UNITED STATES PATENT AND TRADEMARK OFFICE

10/806,870

Office Action Summary	Application No. 10/806,870	Applicant(s) RIVERS ET AL.	
	Examiner Christine T. Cajilig	Art Unit 3637

DETAILED ACTION

Edwards (U.S. Patent No. 6,158,180).

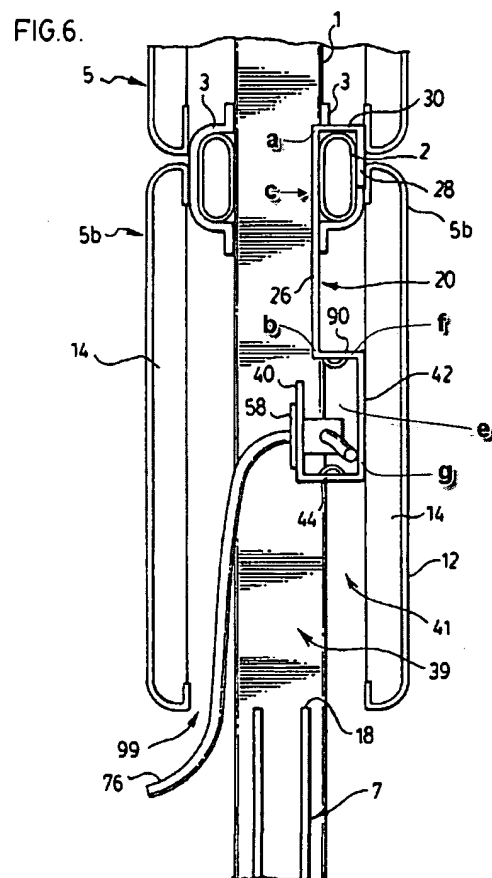
Regarding claim 1, Edwards in Figure 6 discloses a wire channel device for use with an upper siding panel and a lower siding panel, the wire channel device comprising an upwardly extending arm (26) having a top portion (a), a bottom portion (b), an inner surface (c), and an outer surface (20), the outer surface (20) of the top portion (a) having a wedgeable projection (30, 28) to engage and to secure the wire channel device between an upper siding panel and a lower siding panel; a transverse leg (90) extending outwardly from the outer surface of the bottom portion of the arm towards a downwardly extending leg (42) of a wire channel; the wire channel having the downwardly extending leg (42), a channel portion (44), and a rear upwardly extending

Regarding claim 2, Edwards in Figure 6 discloses a wire channel wherein the channel portion comprises a substantially "U"-shaped channel (44).

Regarding claim 12, Edwards in Figure 6 discloses a wire channel wherein the projection comprises at least one substantially hook-shaped lip (30, 28).

Regarding claim 13, Edwards in Figure 6 discloses a wire channel wherein the hook-shaped lip (30, 28) has an interior angle relative to the outer surface of the top portion of at least fifteen degrees.

Regarding claim 15, Edwards in Figure 6 discloses a wire channel comprising at least one upwardly extending arm (26) having a wedgeable projection (30, 28) capable of engaging and securing the wire channel device between the upper siding panel and the lower siding panel; a transverse leg (90) extending outwardly from the arm towards a downwardly extending leg (42) of a wire channel, wherein the transverse leg is

capable of extending beneath a rearwardly facing hook portion of the upper siding panel; the wire channel having the downwardly extending leg (42), a channel portion (44), and a rear upwardly extending leg (40), wherein the downwardly extending leg (42) is longer than the rear upwardly extending leg (40) and wherein the channel portion (44) defines a channel (e) to retain a wire. As noted above, for purpose of examination the claims are considered as directed to the wire channel device; therefore, the phrases, "for use with an upper siding panel and a lower siding panel, the upper siding panel having a rearwardly-facing hook portion and a lip portion and the lower siding panel having a hooked portion complementary to the lip portion of the upper siding panel," "to engage and to secure the wire channel device between the upper siding panel and the lower siding panel," and "wherein the transverse leg extends beneath a rearwardly-facing hook portion of an upper siding panel" shall be considered as functional language or intended use. And while features of an apparatus may be recited either structurally or functionally, claims directed to an apparatus must be distinguished from the prior art in terms of structure rather than function. Examiner refers Applicant to MPEP §2114.

Regarding claim 16, Edwards in Figure 6 discloses a wire channel comprising the at least one upwardly extending arm (26) having a top portion (a), a bottom portion (b), an inner surface (c), and an outer surface (20), the outer surface (20) of the top portion (a) having the wedgeable projection (30, 28) capable of engaging and securing the wire channel device between the lip portion of the upper siding panel and the complimentary hooked portion of the lower siding panel, and a portion of the outer surface (20) of the

Reinke (U.S. Patent No. 1,772,687)

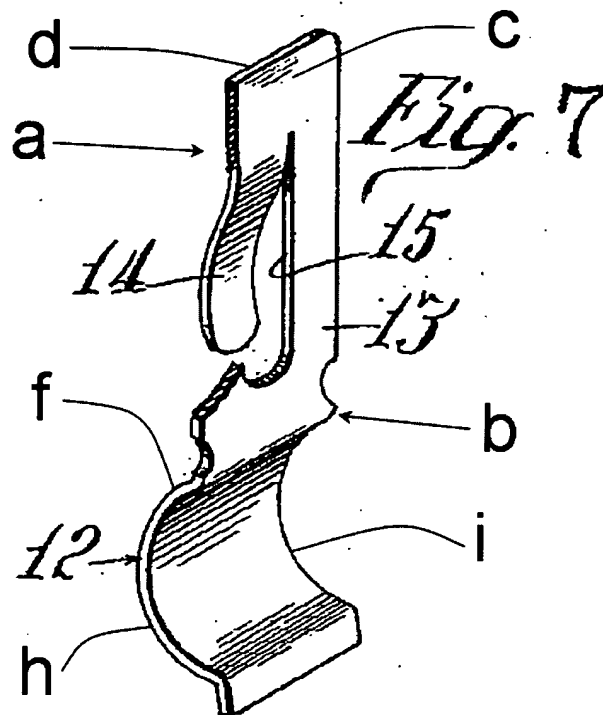
Regarding claim 1, Reinke in Figure 7 discloses a wire channel device for use with an upper siding panel and a lower siding panel, the wire channel device comprising: an upwardly extending arm (13) having a top portion (a), a bottom portion (b), an inner surface (c), and an outer surface (d), the outer surface (d) of the top portion (a) having a wedgeable projection (14) to engage and to secure the wire channel device between an upper siding panel and a lower siding panel; a transverse leg (f) extending outwardly from the outer surface of the bottom portion of the arm towards a downwardly extending leg (12) of a wire channel; the wire channel having the downwardly extending leg (12), but does not disclose a channel portion and a rear upwardly extending leg, wherein the downwardly extending leg is longer than the rear upwardly extending leg and wherein an interior of the channel portion defines a channel to retain a wire. However, Sugiyama disclose a securing device with a channel (a) and a rear upwardly extending leg (2') wherein an interior of the channel portion defines a channel to retain

Regarding claim 12, Reinke already modified by Sugiyama discloses a wire channel as discussed above and further discloses that the wedgeable projection comprises at least one substantially hook-shaped lip (14).

Regarding claim 15, Reinke discloses a wire channel comprising at least one upwardly extending arm (2) having a wedgeable projection (14) capable of engaging and securing the wire channel device between the upper siding panel and the lower siding panel; a transverse leg (f) extending outwardly from the arm towards a downwardly extending leg (12) of a wire channel, wherein the transverse leg is capable of extending beneath a rearwardly facing hook portion of the upper siding panel; the wire channel having the downwardly extending leg (12), but does not disclose a channel portion, and a rear upwardly extending leg, wherein the downwardly extending leg is longer than the rear upwardly extending leg and wherein the channel portion defines a channel to retain a wire. However, Sugiyama disclose a securing device with a channel (a) and a rear upwardly extending leg (2') wherein an interior of the channel portion defines a channel to retain tubular members (P). Therefore, it would have been obvious to a person having ordinary skill in the arts at the time of the Applicant's invention to modify Reinke to have a channel portion with a rear upwardly extending leg as taught by Sugiyama to provide a clamping means to better secure wires that will be held within the channel. As noted above, for purpose of examination the claims are considered as directed to the wire channel device; therefore, the phrases, "for use with an upper siding panel and a lower siding panel, the upper siding panel having a rearwardly-facing hook portion and a lip portion and the lower siding panel having a hooked portion

FIG. 29

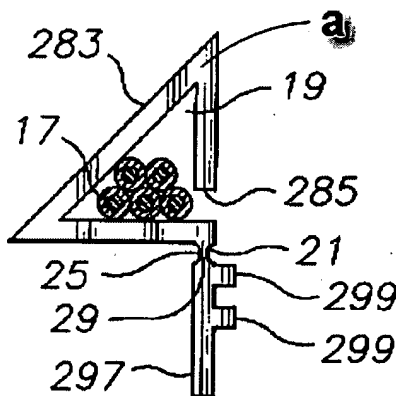
Regarding claim 4, Edwards discloses a wire channel as discussed above but does not disclose a channel portion comprising a substantially "V"-shaped channel. However, Zimmerman in Figure 29 discloses a flanged conduit having a channel portion (a) comprising a substantially "V"-shaped channel (19). Therefore, it would have been

Regarding claim 10, Edwards discloses a wire channel as discussed above but does not disclose the downwardly extending leg extending downward at an angle of at least thirty degrees toward the transverse leg. However, Zimmerman in Figure 29 discloses a flanged conduit having the downwardly extending leg (283) extending downward at an angle of at least thirty degrees toward the arm (297). Therefore, it would have been obvious to a person having ordinary skill in the arts at the time of the applicant's invention to modify the wire channel of Edwards to include the downwardly extending leg extending downward at an angle of at least thirty degrees toward the transverse leg to provide a channel with a variety of configurations (Col 2, Ln 19-21).

Brooks (U.S. Patent No. 5,823,655)

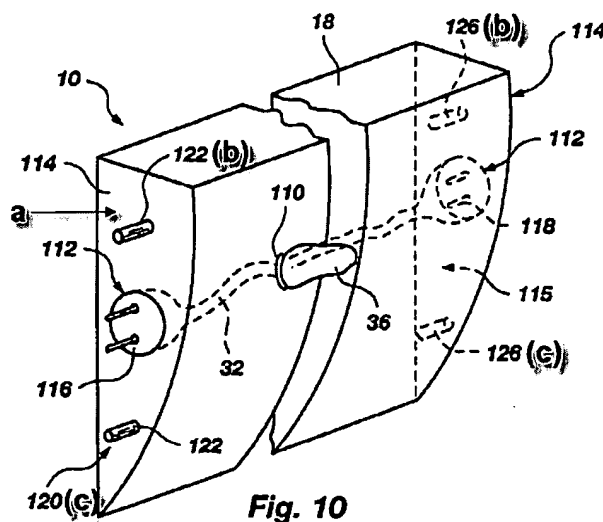
Regarding claims 5 and 17, Edwards discloses a wire channel as discussed above and also including transverse leg (90) comprising a first lateral side (f) and a second lateral side (opposite side of (f)) but does not disclose the first lateral side having a female repository and the second lateral side having a male projection, wherein the male projection of a first wire channel device mates with the female repository of a second wire channel device such that the first wire channel snap fits into alignment and secures with the second wire channel. However, Brooks in Figure 10 discloses channeled molding having a transverse leg (114) further comprising a first lateral side (115) and a second lateral side (a), the first lateral side having a female repository (126 (b)) and the second lateral side having a male projection (122 (b)), wherein the male projection of a first wire channel device mates with the female repository of a second wire channel device such that the first wire channel snap fits into alignment and secures with the second wire channel (Col 7, Ln 54-56). Therefore, it would have been obvious to a person having ordinary skill in the arts at the time of the applicant's invention to modify the wire channel of Edwards to include the first lateral side having a female repository and the second lateral side having a male projection, wherein the male projection of a first wire channel device mates with the female repository of a second wire channel device such that the first wire channel snap fits into

Regarding claims 6 and 18, Edwards discloses a wire channel as discussed above and also disclose that the channel portion further comprises a first lateral side (g) and a second lateral side (opposite side of (g)) but does not disclose the first lateral side having a female repository and the second lateral side having a male projection, wherein the male projection of a first wire channel device mates with the female repository of a second wire channel device to align and secure the first wire channel device with the second wire channel device. However, Brooks in Figure 10 discloses channeled molding having a first lateral side (115) and a second lateral side (a), the first lateral side having a female repository (126 (c)) and the second lateral side having a male projection (122 (c)), wherein the male projection of a first wire channel device mates with the female repository of a second wire channel device such that the first wire channel snap fits into alignment and secures with the second wire channel (Col 7, Ln 54-56). Therefore, it would have been obvious to a person having ordinary skill in the arts at the time of the applicant's invention to modify the wire channel of Edwards to have the channel portion further comprise a first lateral side having a female repository and the second lateral side having a male projection, wherein the male projection of a first wire channel device mates with the female repository of a second wire channel device such that the first wire channel snap fits into alignment and secures with the second wire channel as taught by Brooks to provide a means for extending the length of the channel. Furthermore, it has been held that the mere rearrangement of parts, such
